DART Steering Boot coming off.

Property name and Top bus number: DART - 304500 - 306500 - 313000 – 314000 - 323000

Engineering Documentation: N14 -35653

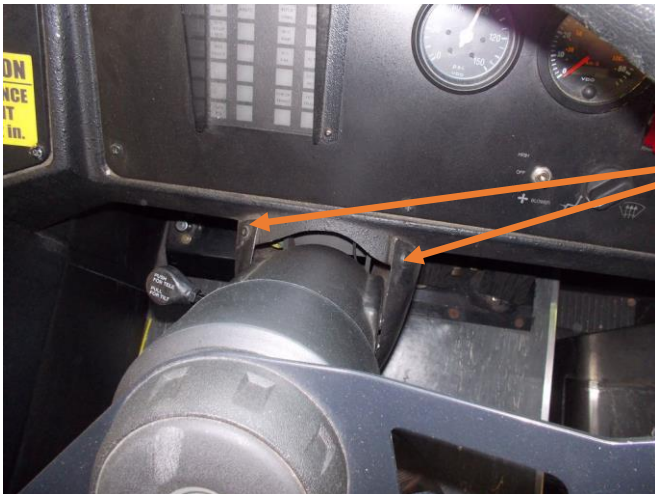
Issue: Steering column rubber boot dust seal is becoming loosening and is not staying in place.

Reason/ cause: Exact cause has not been determined, but appears to be insufficient clamping force of the boot to the stationary part of the column.

Solution: Add a hose type clamp to rubber boot to hold it in place.

4. Add hose clamp to steering column boot to hold boot in place. Make sure boot is down and in place and clamp screw is positioned towards the front of the bus.
